SUBJECT: Freeport-Albertus Airport
Freeport, Illinois
Stephenson County
Illinois Project Number: FEP-5057
SBG Project Number: 3-17-SBGP-TBD
Contract No. FR048
Item No. 03A, November 7, 2025 Letting
Addendum A

Clarify PAPI System requirements on the plans.

REHABILITATE
RUNWAY 6/24
PAPI SYSTEM

Sheet 16 – PAPI Details

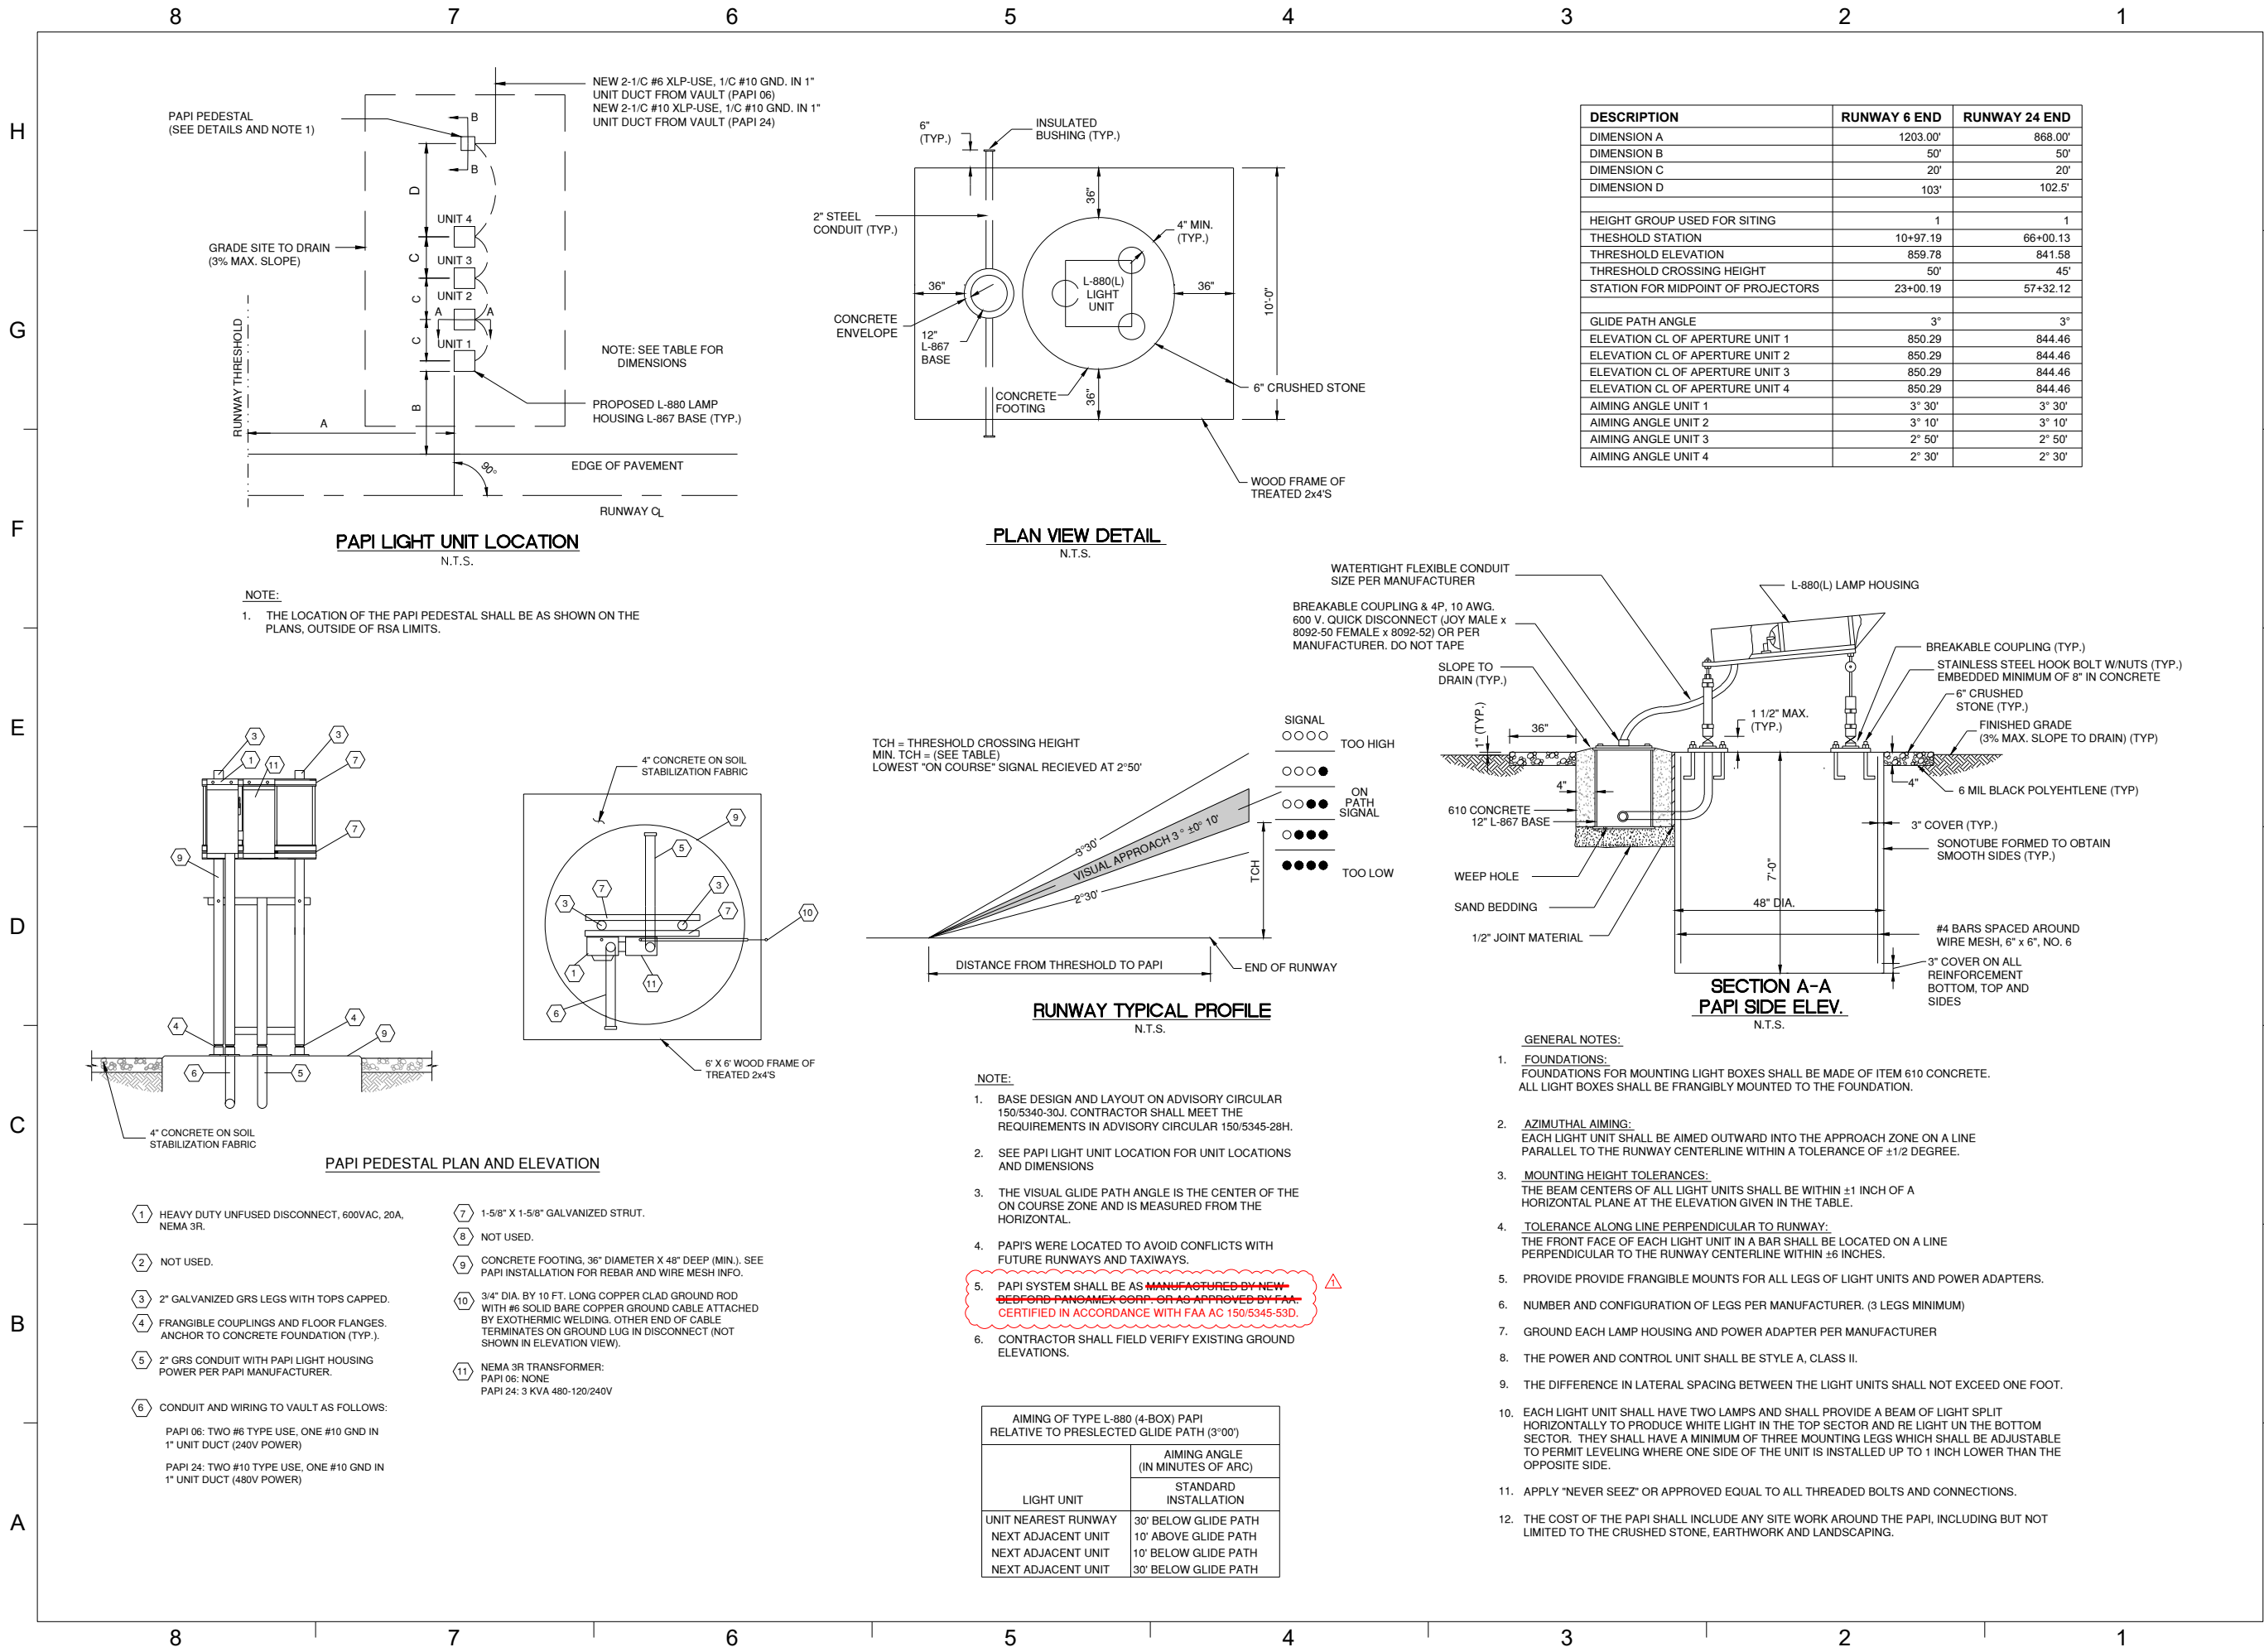
1. Revise Note 5 to “PAPI System shall be as certified in accordance with FAA AC 150/5345-53D.”

10/15/25 REVISE NOTE 5
